Subject: AP1000 Response to Request for Additional Information (SRP3.12)

Response to Request for Additional Information on SRP Section 3.12

AP1000 TECHNICAL REPORT REVIEW

RAI Response Number: RAI-SRP3.12-EMB-01

Figure 6.3.2.1-1: APP-PXS-PLA-030 Floor Response Spectra X-Direction

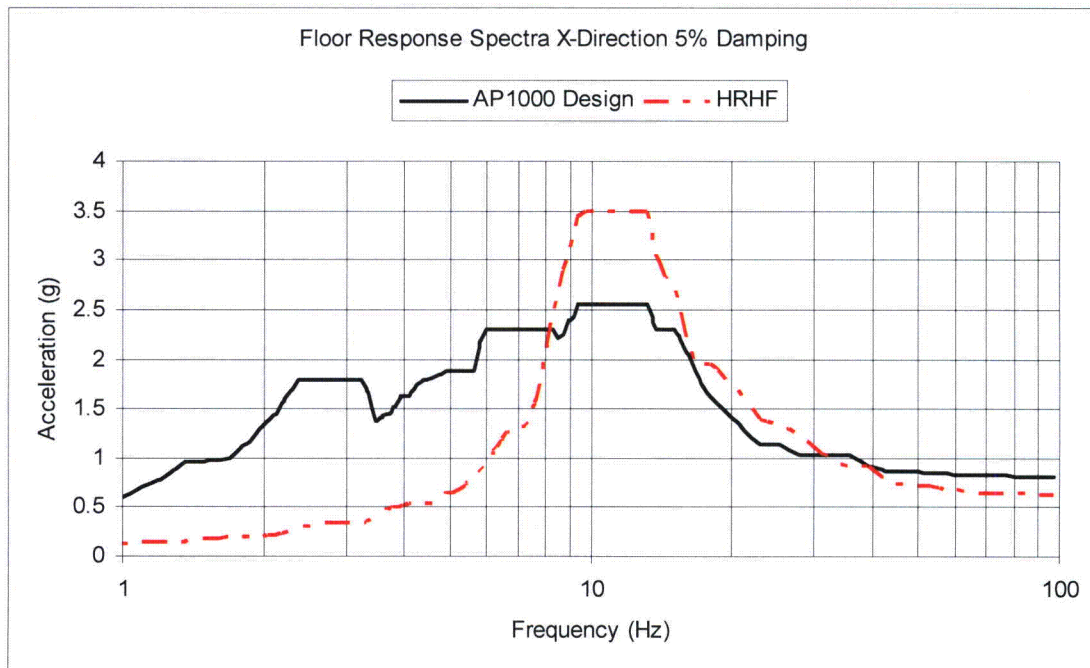
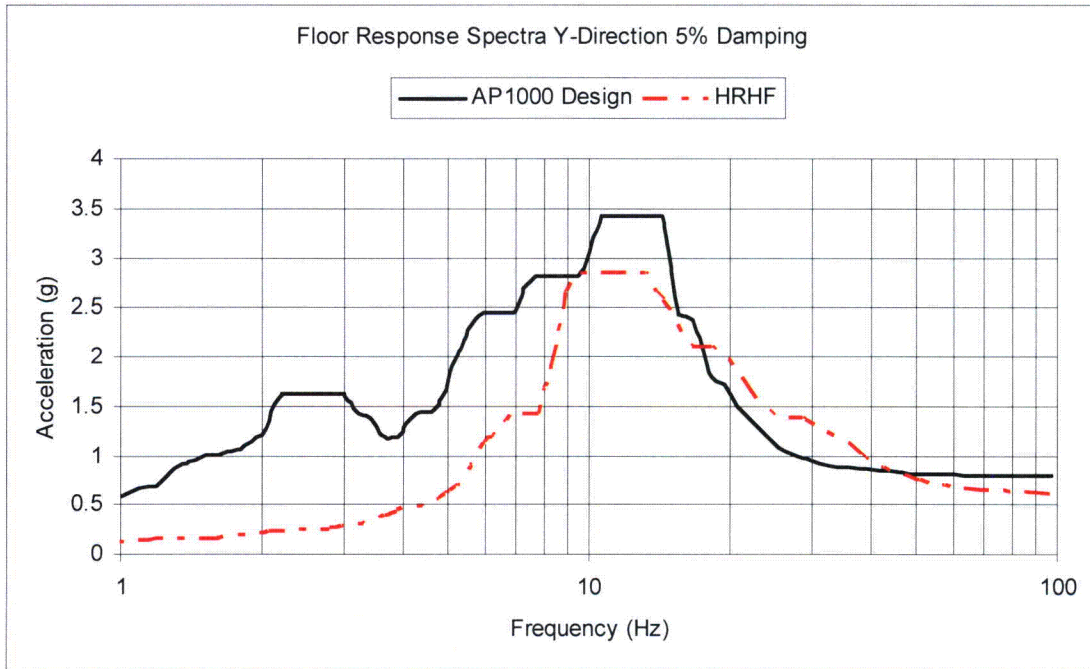
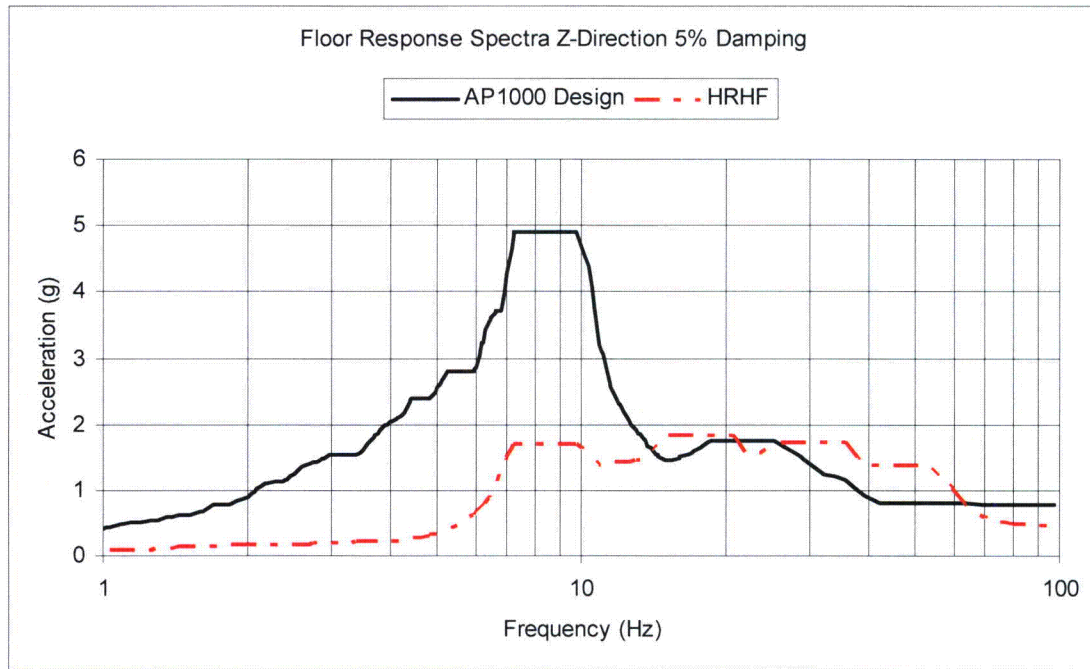
What is the justification for stating that the two piping systems chosen are representative for all piping systems? For example, the floor response spectrum at Elevation 134.25' of the Containment Building has more exceedance in the high frequency region than those used in the demonstration. Floor Response Spectra should be taken into account in determining which packages envelope the complete piping design.

Both the AP1000 CSDRS and HRHF GMRS have been enveloped across entire building elevations. This is not only a conservative approach, but this also eliminates concerns of building location as the spectra is representative of an entire elevation.

Figures 6.3.2.1-1 through 6.3.2.1-3 are the plots of the AP1000 CSDRS with 5% damping and HRHF GMRS with 5% damping and incoherence. The response spectra for both AP1000 CSDRS and HRHF GMRS are representative of the containment building up to elevation 135'.
